CERTIFICATE OF APPROPRIATENESS**Application Date:** August 31, 2016**Applicant:** Sean O'Quinn, Scott+Reid General Contractors for Timothy Ronan, Jr., SRC Franklin Owner, LP, owner**Property:** 805 Franklin Street, Lots 3, 4, & 5, Block 16, SSBB Subdivision. The property is a vacant lot situated on a 15,002 square foot (150' x 100') corner lot.**Significance:** The property is a vacant lot located in the Main Street Market Square Historic District.**Proposal:** New Construction – *This project was deferred at the July and August 2016 HAHC meetings so that the applicant could further work with staff.*

Recommendation: Approval**HAHC Action:** Approved**CERTIFICATE OF APPROPRIATENESS****Basis for Issuance:** HAHC Approval**Effective:** September 22, 2016

APPROVAL CRITERIA**NEW CONSTRUCTION IN A HISTORIC DISTRICT**

SOUTH ELEVATION –FACING FRANKLIN STREET (COMPARISON)

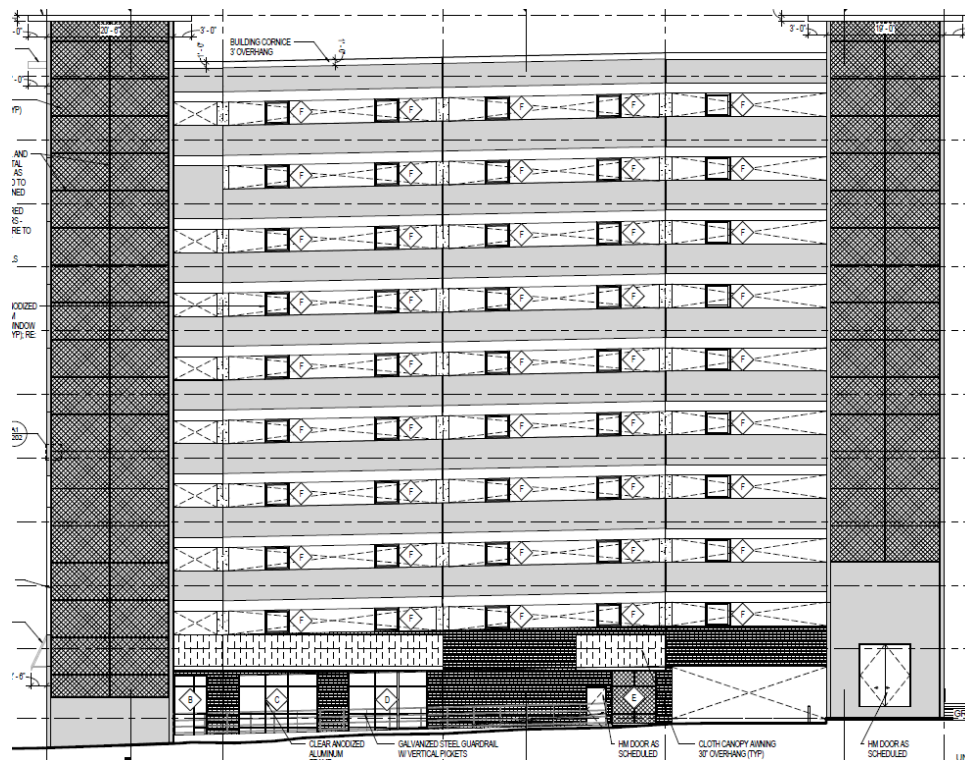
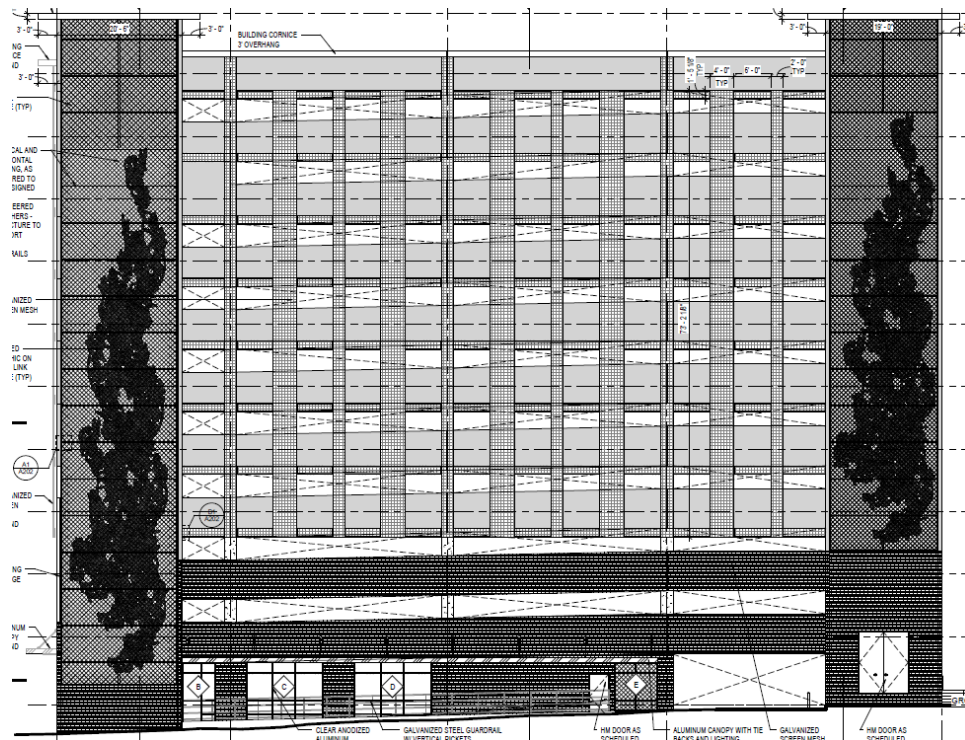
Front Elevation: Deferred July and August 2016: The proposed south elevation features a faux storefront topped by a cloth awning on the ground level. The garage entrance/exit is located on the eastern portion of the ground level. The second through ninth stories each feature five square aluminum frames. The main central portion of the structure is flanked by two stair towers. The towers are clad in chain link fencing. The roof of the structure features a parapet wall topped by a cornice.

Proposed September 2016: The proposed south elevation features a faux storefront topped by suspended metal awnings. A garage entrance/exit is located on the eastern portion of the ground level. The first two stories will be clad in brick veneer. Beginning at the bottom of the third level, horizontal and vertical mesh screens will be installed to give the appearance of differentiated bays. The horizontal screens delineate floors while the alternating wide and narrow vertical mesh panels delineate the bays. The main central portion of the structure is flanked by two stair towers. The south elevations of the towers are open and clad in chain link fencing. The roof of the structure features a parapet wall topped by a cornice. See drawings for more detail.

WEST ELEVATION – FACING MILAM STREET (COMPARISON)

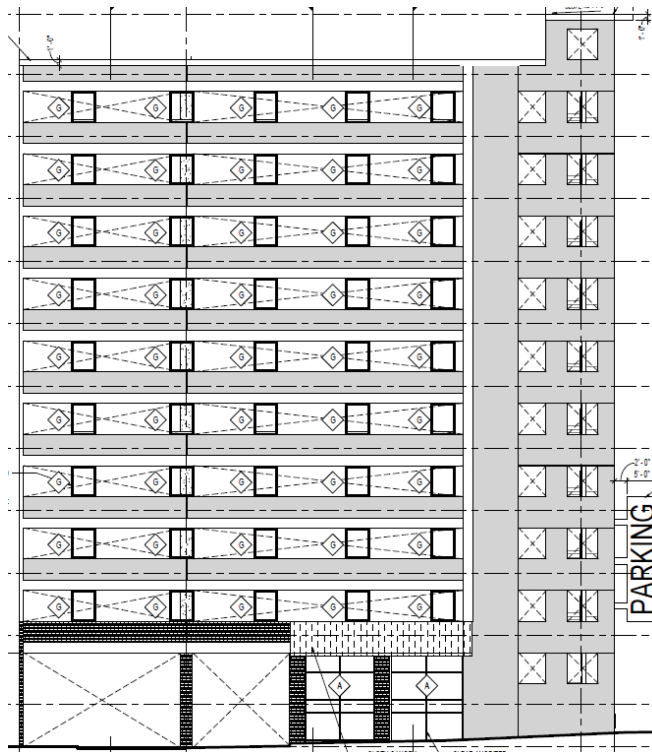
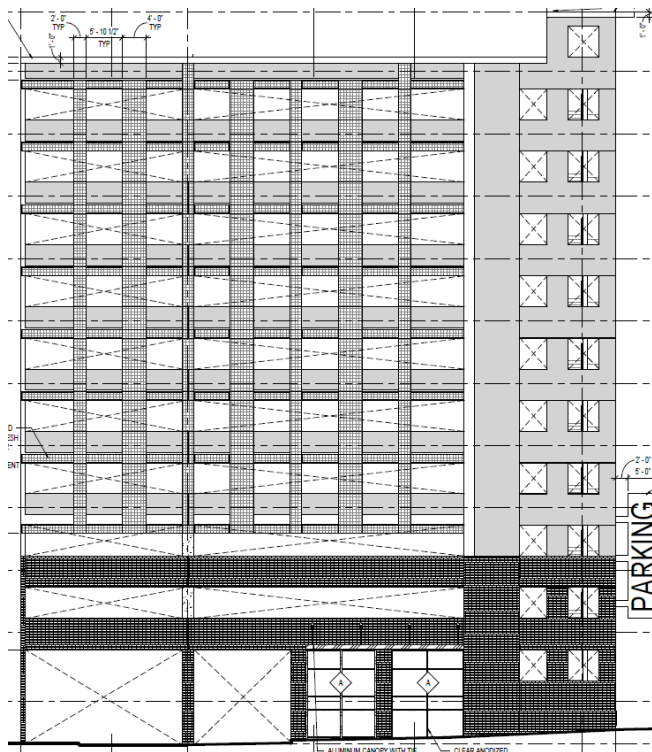
Side Elevation: Deferred July and August 2016: The proposed west elevation features a faux storefront topped by a cloth awning on the ground level. The garage entrance/exit is located on the northern portion of the ground level. The second through ninth stories each feature five rectangular aluminum frames. The stair tower is located to the south and each level features a pair of square openings. The top level features a single square opening. The roof of the structure features a parapet wall topped by a cornice.

Proposed September 2016: The proposed west elevation features a faux storefront topped by suspended metal awnings. Two garage entrances/exits are located on the northern portion of the ground level. The first two stories will be clad in brick veneer. Beginning at the bottom of the third level, horizontal and vertical mesh screens will be installed to give the appearance of differentiated bays. The horizontal screens delineate floors while the alternating wide and narrow vertical mesh panels delineate the bays. The stair tower is located to the south and each level features a pair of square openings. The top level features a single square opening. The roof of the structure features a parapet wall topped by a cornice. See drawings for more detail.

EAST ELEVATION

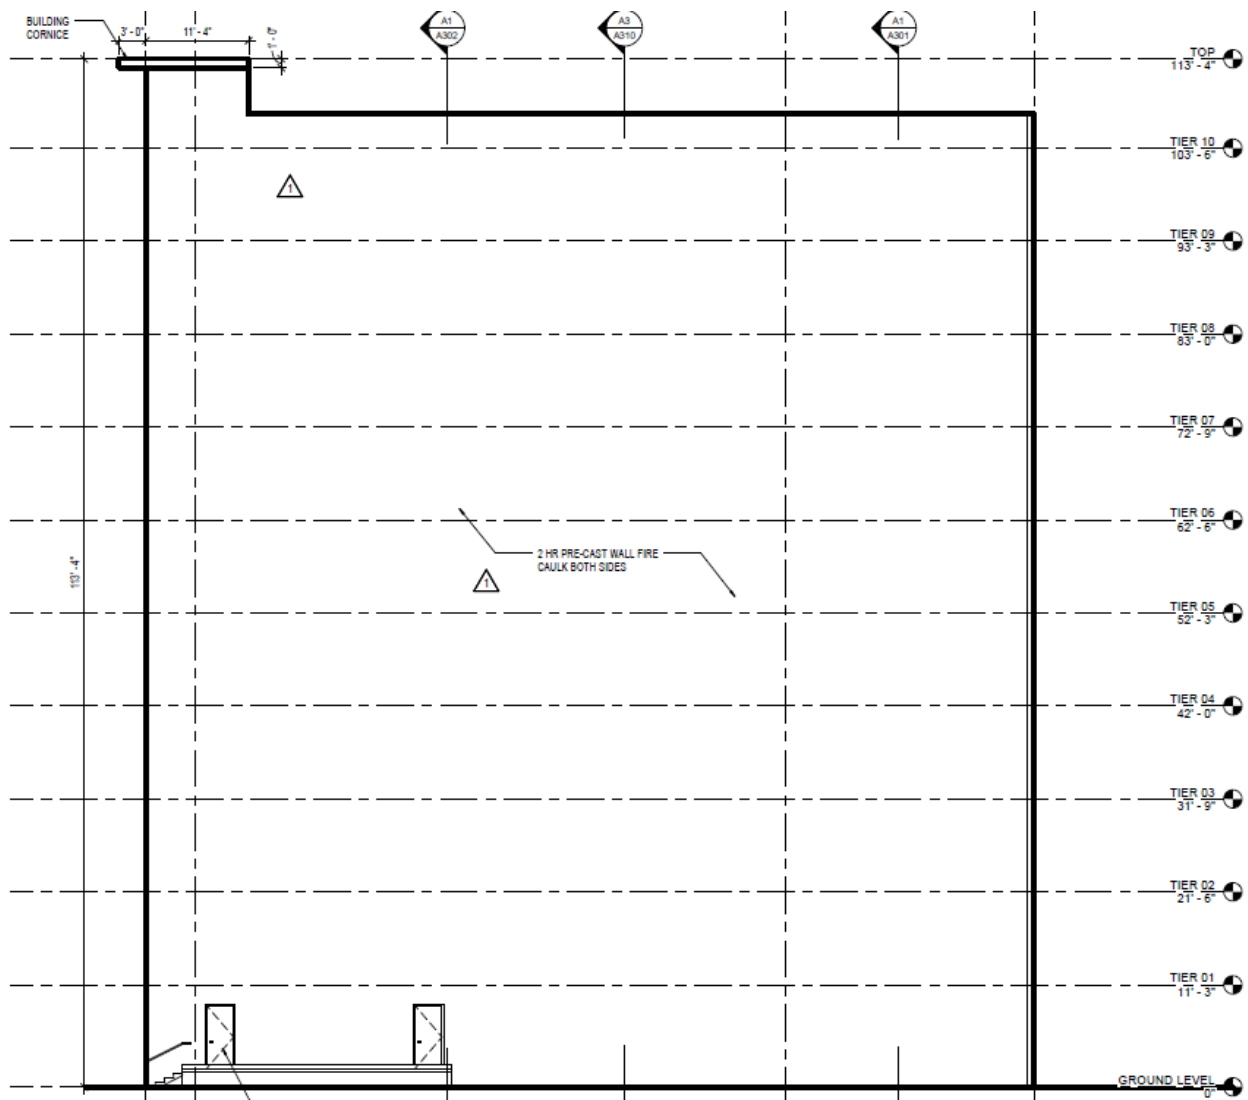
Side Elevation: The proposed east elevation is comprised of a precast concrete wall with no fenestration. Two doors are located at ground level. See drawings for more detail.

NORTH ELEVATION
PROPOSED SEPTEMBER 2016

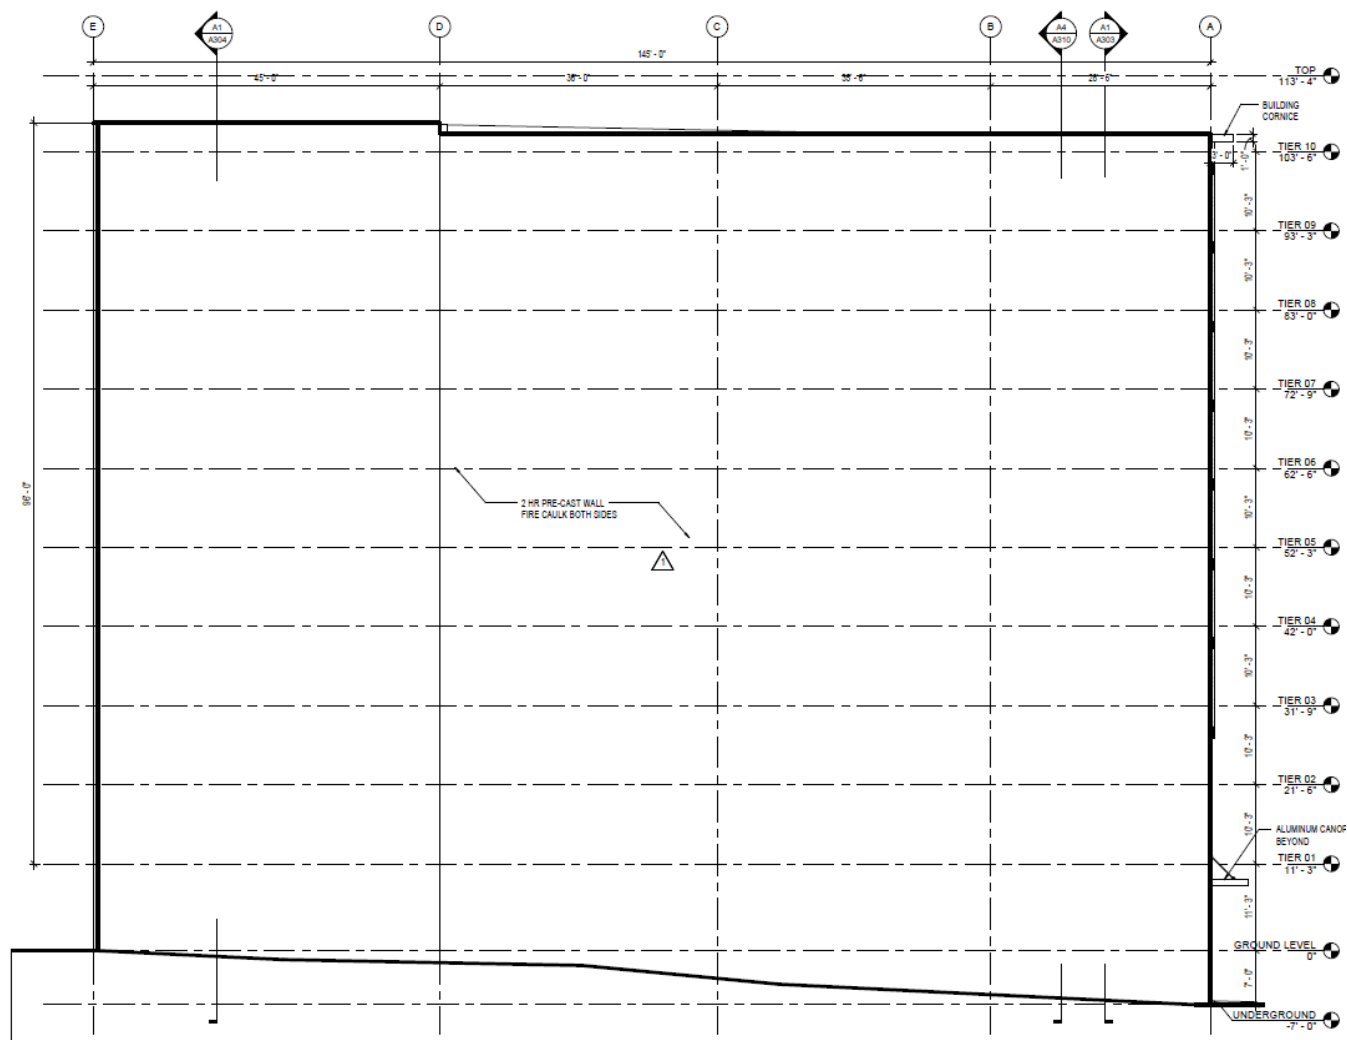
Rear Elevation: The proposed east elevation is comprised of a precast concrete wall with no fenestration or doors. See drawings for more detail.
